HISTORIC PRESERVATION BOARD STAFF REPORT

160 Marine Way

Meeting	File No.	Application Type
August 5, 2026	HP-417-2026	Certificate of Appropriateness & Waiver

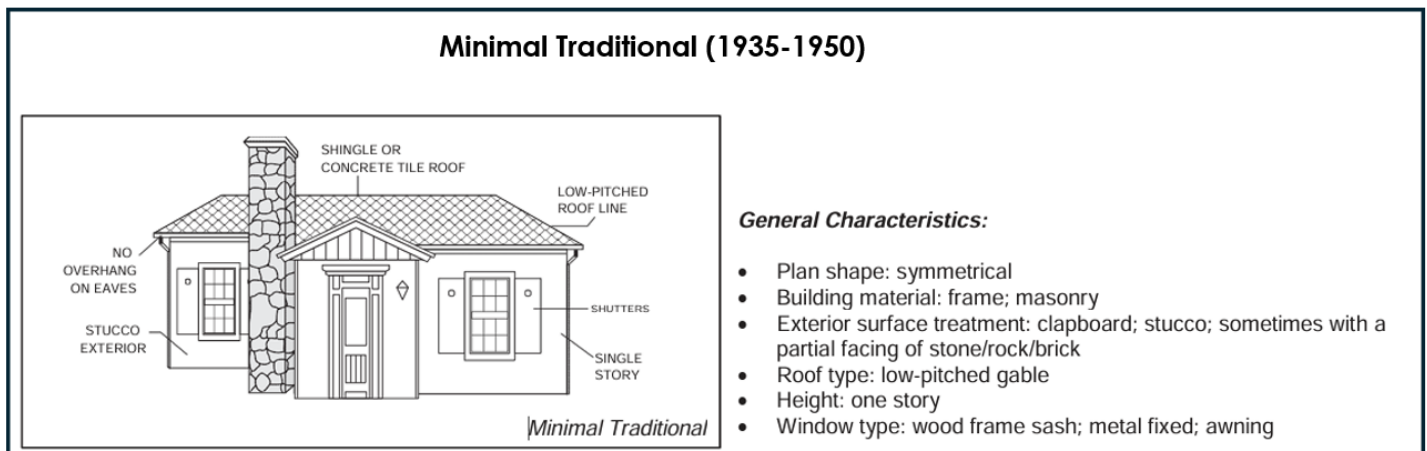
With regard to **Relationship of Materials, Texture, and Color and Roof**, the subject request includes the replacement of the existing wood trellises with aluminum, stucco exterior on the third-floor, aluminum framed windows & shutters, and replacement of the existing, 5-V crimp, mill finish, metal roof with a white standing seam metal roof. The addition of an eyebrow feature on the two double doors on the north elevation will also match the standing seam metal roof in “Drexel Metals” Stone White/Kynar 500 Fin.

The use of standing seam and 5-V crimp metal roofs within historic districts are required to be reviewed by the board and are on a case-by-case basis, to ensure visual compatibility with other structures and the districts as a whole. It is noted however, that aluminum shingle roofing has been deemed compatible for historic structures within the districts and can be approved administratively. While the board has approved metal roofs for historic structures, typically the color of the metal is “mill finish” or silver. This is because historically when metal roofs may have been utilized at the time of original construction, metal was only available in its natural color, not a painted finish. The most appropriate roof material is what was historically utilized, in this case this originally home had a shingle roof. However, the board

previously approved the use of a 5-V crimp metal roof for this structure – in a mill finish. The use of metal roofing has increased, given the city's location within a hurricane prone area and many owners have requested the use of metal roofs to aid in reducing insurance premiums and improve a structure's resiliency to storms.

It is also noted, that the existing roof needs replacement and the property owner sought a building permit (BLDR-016097-2027) to replace the roof with a white standing seam metal roof. Staff advised that such is a board reviewed item, and the property owner requested that the city approve the roof material and white color with the caveat that they would sign a Hold Harmless agreement, stating that they would take the risk of utilizing the white color metal roof without the board's approval. The permit was issued on 7/24/2026 and the roof replacement has occurred. The board will need to make a determination that the proposed white, standing seam metal roof is appropriate for use on this contributing structure.
